1 **PARK COUNTY PLANNING & ZONING DEPARTMENT**
2 Staff Report – Planning & Zoning Commission
3 Lohrenz Minor Subdivision-81 (MS-81) – Public Hearing
4 Sketch Plan Review
5

7 **Applicant:** Rusty Blough

Figure 1: Lohrenz MS-81 Sketch Plan

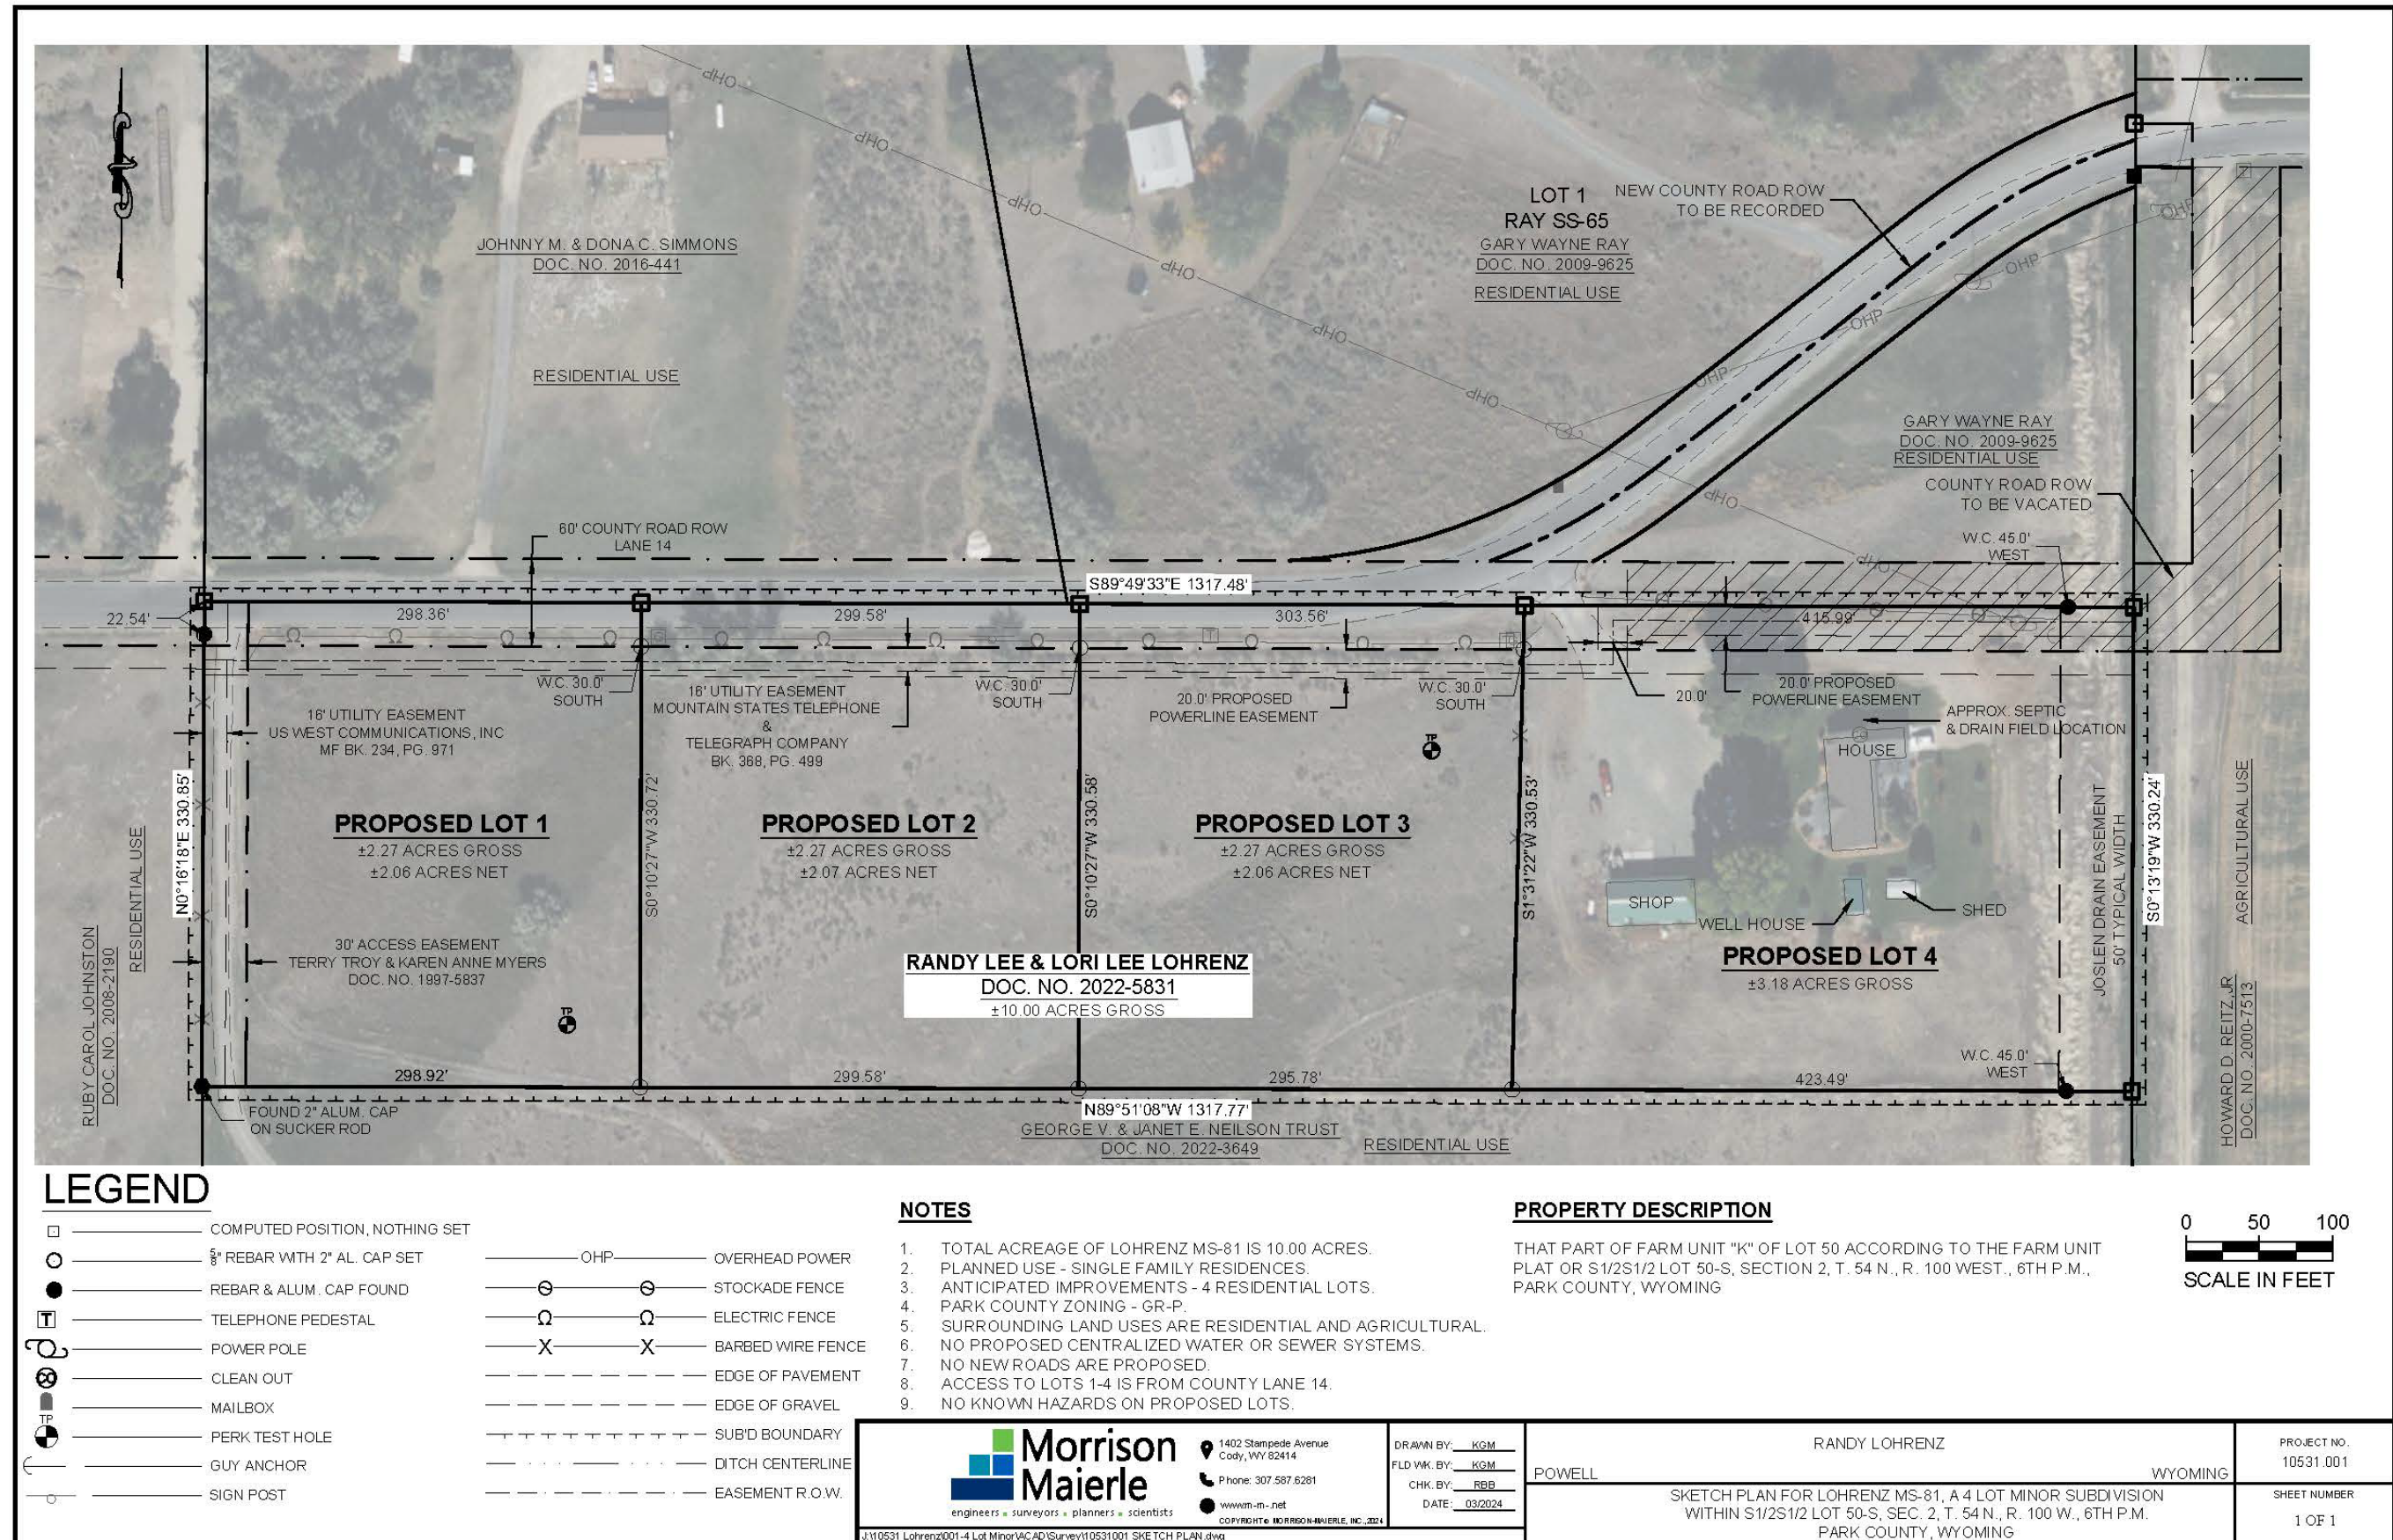
- 232 D. Existing structures, wells and septic facilities; **Existing structures,**
233 **wells and septic facilities are shown on the sketch plan.**
- 234 E. Irrigation facilities including laterals, head gates and waste ditches,
235 and direction of flow where flood irrigation is proposed; **The Joslen**
236 **Drain is shown on the sketch plan.**

- 237 i. Means of access from the lots to the public road system;
238 **Access to each proposed lot is directly from County Lane**
239 **14.**
- 240 ii. All lots and parcels shall have legally enforceable access.

- 241 iii. In the case of direct access to a county or state road, the
242 applicants shall submit a valid state or county right-of-way
243 permit or a letter from the governing body indicating favorable
244 “access review” where the specific point of access has not yet
245 been determined.

281 sources for each lot; **Sketch plan shows lot configurations.**
282 **Locations of future structures, septic system(s) and well(s),**
283 **if any, have yet to be determined.**
284 ii. A map showing the locations of percolation tests performed as a
285 component of the application and their stabilized rates. This map
286 shall also show the location and depth to seasonal high
287 groundwater discovered in the trenches excavated for subsurface
288 evaluation. **Locations have been shown on the sketch plan.**
289 C. The above information will be utilized, in part, to determine the type
290 of wastewater treatment system necessary that may include a
291 wastewater treatment solution engineered by a Wyoming Registered
292 Engineer.
293 D. Prior to sketch plan review, the Small Wastewater Administrator shall
294 submit a letter to the Planning Director indicating that septic systems
295 are feasible on the lots and noting any special conditions that may
